2016/08/31

MCRPMD-Ø15~Ø32 Cover and Slider body Surface treatment Changed Notice

MCRPMD-Ø15~Ø32

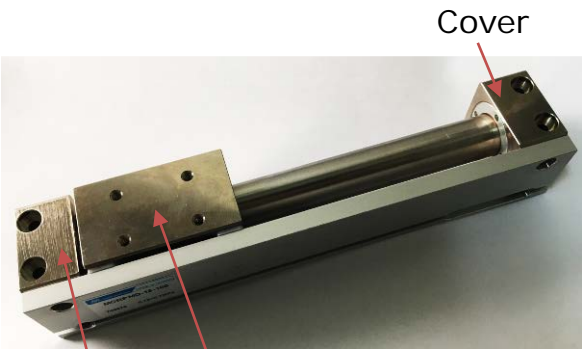
Color: Cover and Slider body From Electroless Nickel Coating color to original color of anodized aluminum.

Before	After
Surface treatment : Electroless Nickel Coating 3~5 μ	Surface treatment : Sandblasting→Original color of anodized aluminum 5~10 μ
 <p>Cover</p> <p>Cover Slider body</p>	 <p>Cover</p> <p>Cover Slider body</p>
